## 4.4 Comments and Responses

Eleven written comments were received during the public comment period from June 9 through July 8, 2009. Nine verbal comments were recorded at the Public Hearing and are included in the transcript in Appendix B.

Written comments were received from the U.S. Army Corps of Engineers (USACE), USFWS, the U.S. Environmental Protection Agency (USEPA), and the CDOW during the comment period and have been included in Appendix D, Agency Coordination and Comments. Letters from the USACE, USFWS, CDOW, and USEPA have been summarized and a response to comments is provided below. Changes to the EA text have been recorded in Section 4.7, Clarifications to the Environmental Assessment.

**FIGURE 4 - 3**  
South Platte River Watershed

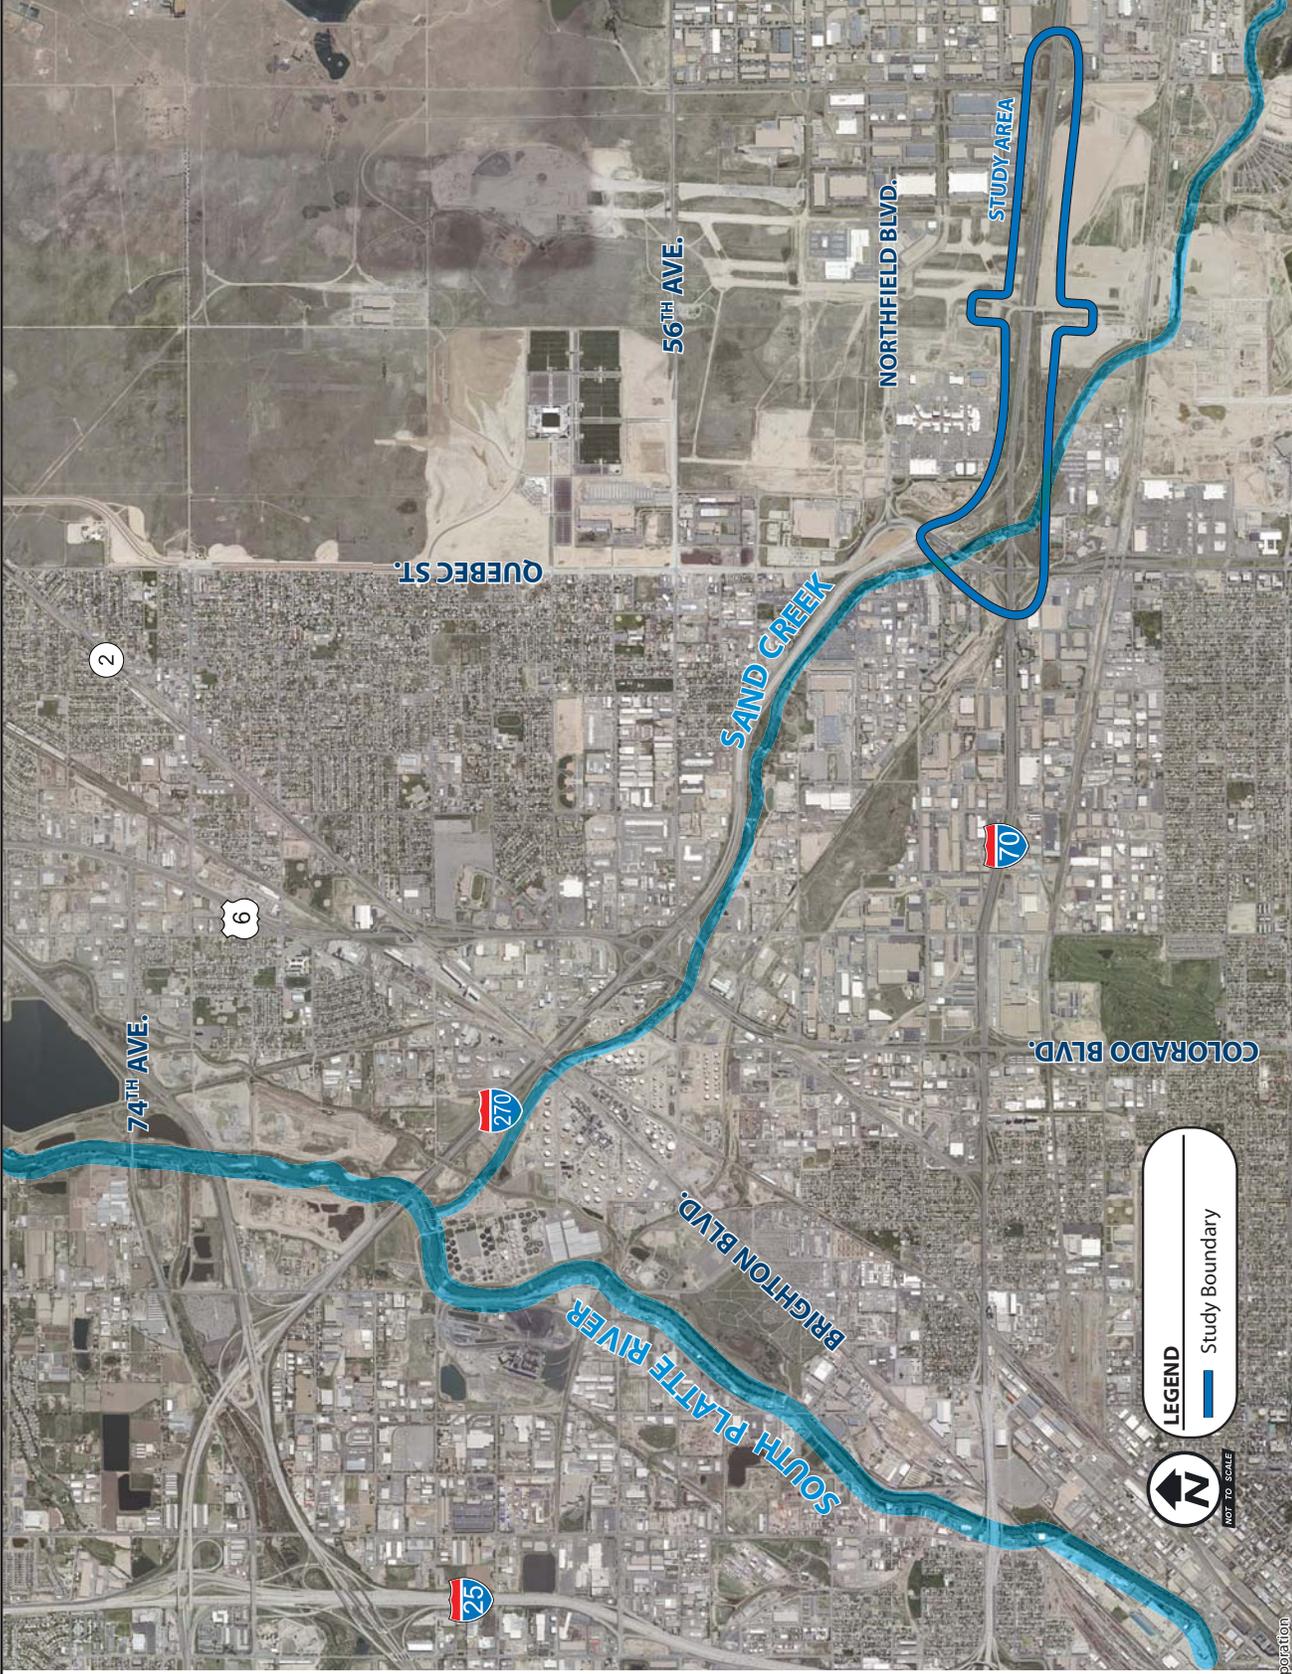
- Disclose whether the indirect impacts of the Preferred Alternative are likely to contribute to impairments of the Aquatic Life Warm Class 2 use and the Recreation Class 1a use for South Platte River Segment 16a (Sand Creek), currently 303(d) listed as impaired for selenium and *E. coli*; (*Information added to pages 4-44 and 4-45 of this FONSI*)

Information suggested above has been added and the revised EA text is located in Section 4.7, Clarifications to the Environmental Assessment.

**FIGURE 4 - 2**  
MESA Site Map

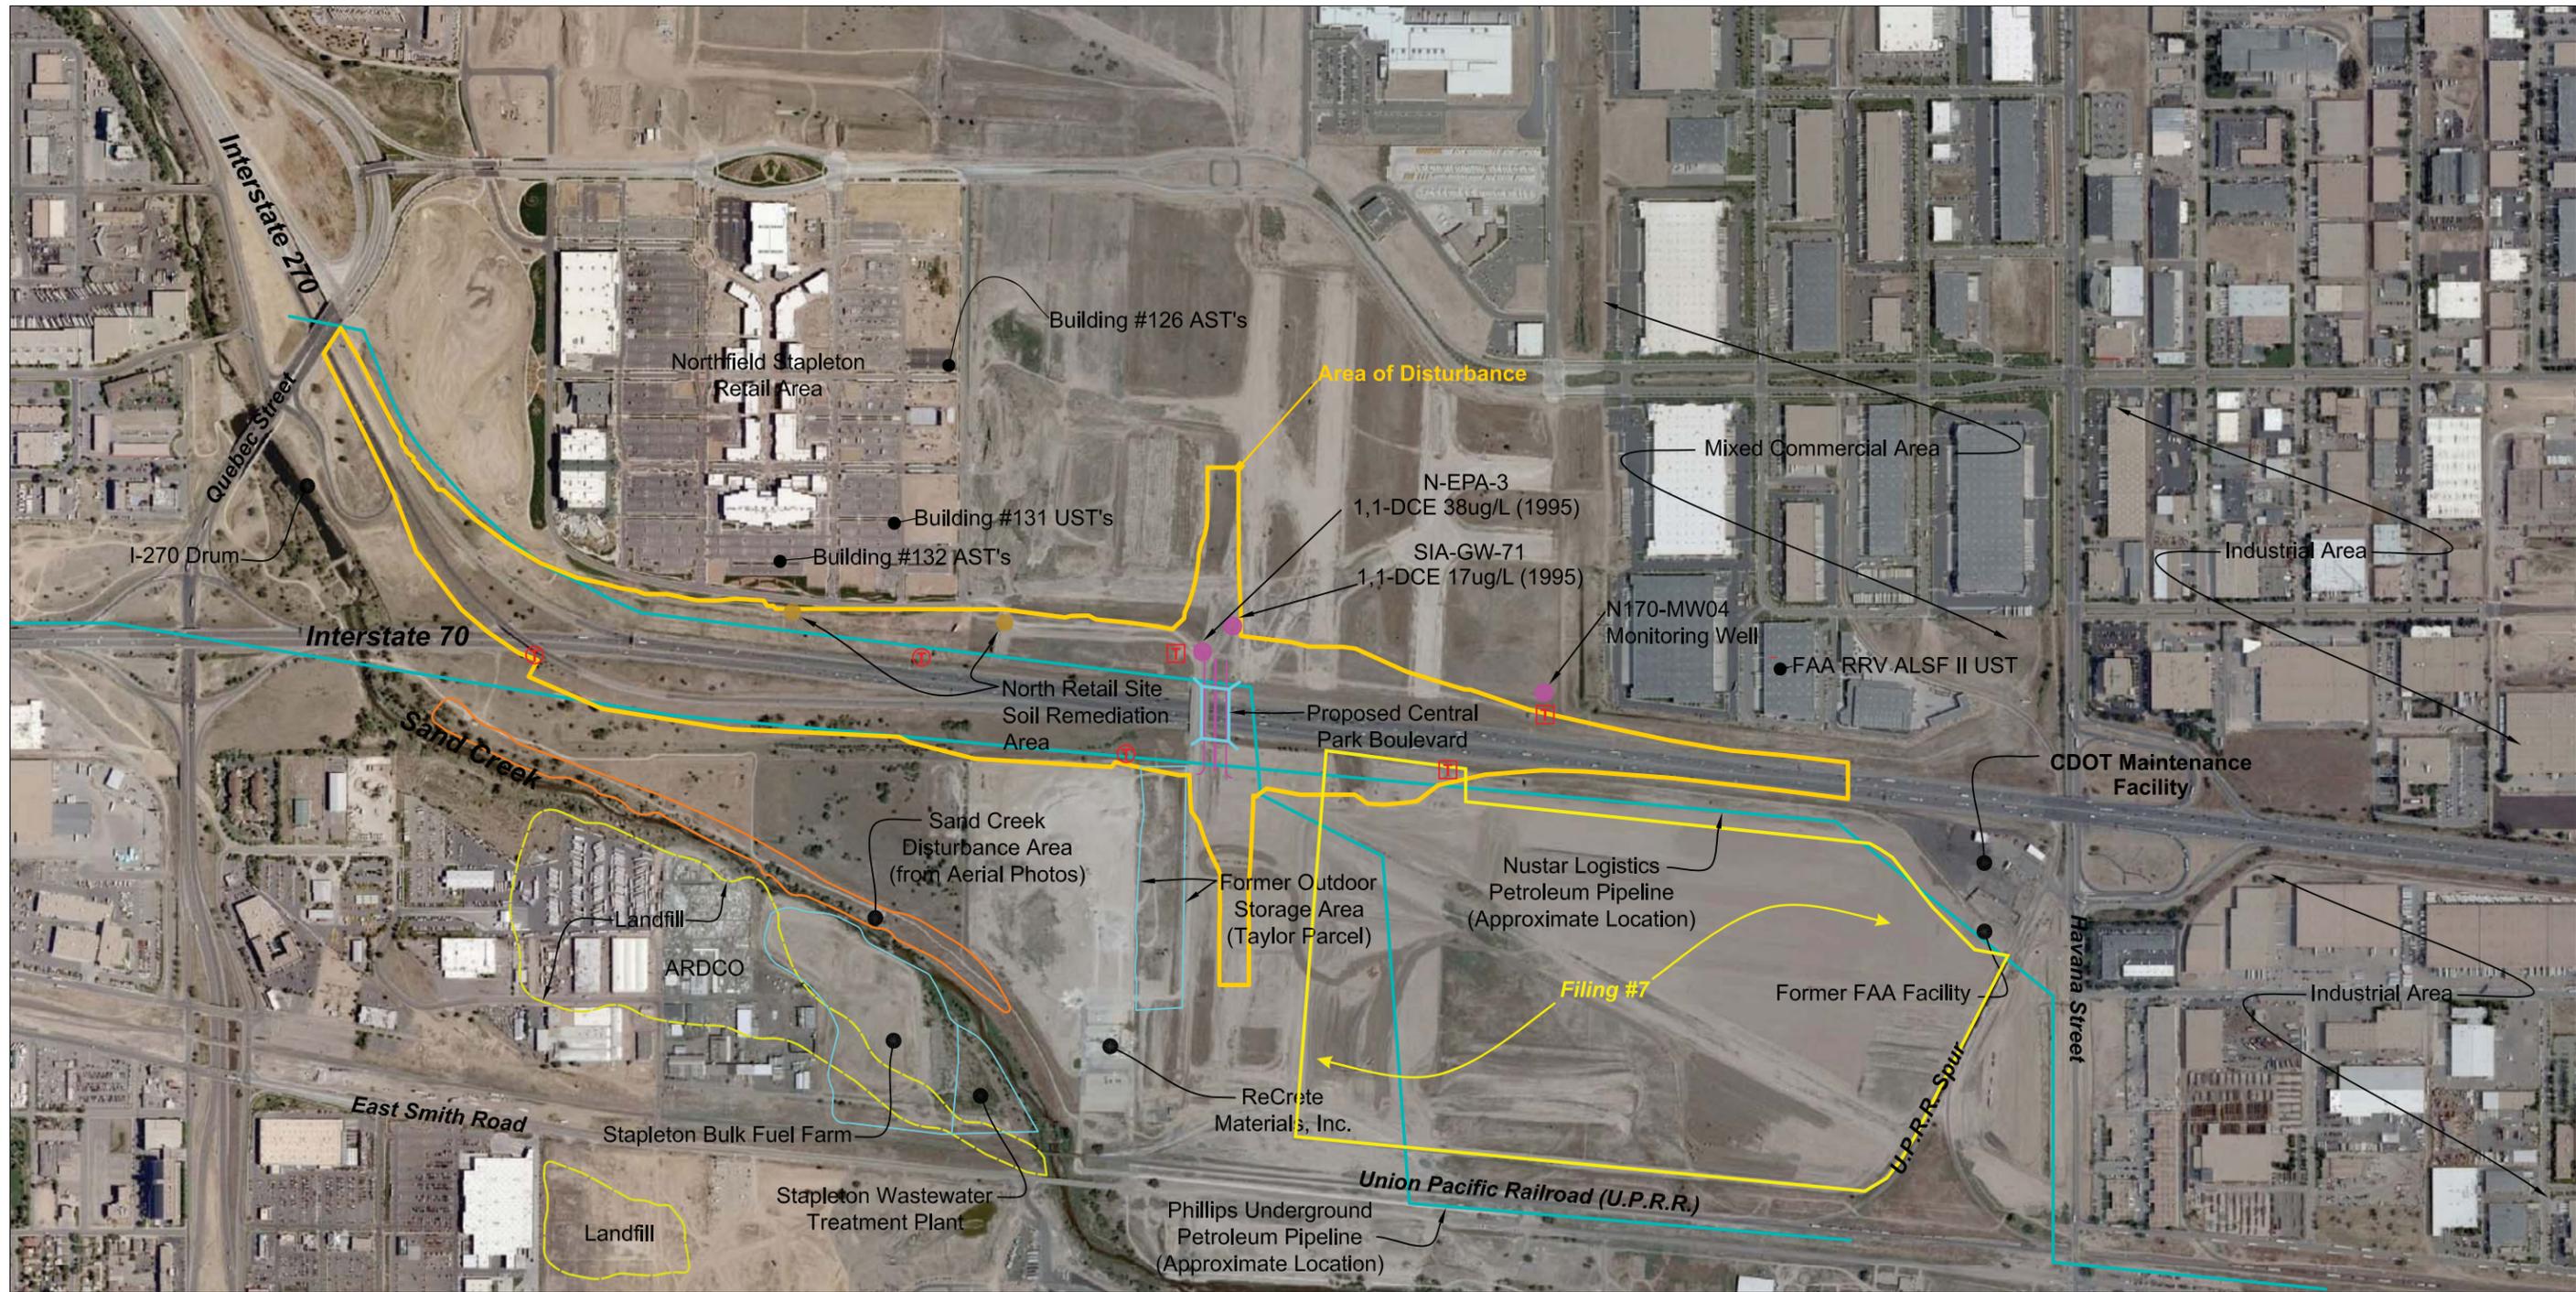
- How sampling programs will be designed to appropriately characterize soils and groundwater/surface water; *(Information added to page 4-55 of this FONSI)*

- How to confirm or deny the presence of contaminants of concern identified in the Phase 1 Recognized Environmental Conditions; *(Information added to page 4-55 of this FONSI)*

- What benchmarks or standards will be used to determine if action is needed to protect worker health and safety (or other receptors, if any); *(Information added to page 4-55 of this FONSI)*

- What the management actions will be (containment/capping, complete removal, or natural attenuation based on lack of receptors and incomplete pathway in the developed areas); and *(Information added to page 4-55 of this FONSI)*

- If transport and disposal will be required, what steps will be taken to ensure that it is done properly and the materials are accepted by appropriate entities. *(Information added to page 4-55 of this FONSI)*

In addition, regulatory action levels used to determine the significance of contamination should be specified. Specifically, on page 4-17, we recommend referring to the regulatory action levels for 1,1-dichloroethene in groundwater. Similarly, if there are action levels for other contaminants of concern in groundwater and soil, the EIS should be clear about the standards that will be used for reference or for cleanup levels. This information should be added to Section 4.3.3 and 4.8.2. Finally, the modified phase I environmental sites assessment refers to the Stapleton Numeric Criteria (SNC). We recommend that you include an explanation of the relationship of the SNC to the Colorado Maximum Contaminant Levels.

The information suggested above has been added and the revised EA text is located in Section 4.7, Clarifications to the Environmental Assessment.
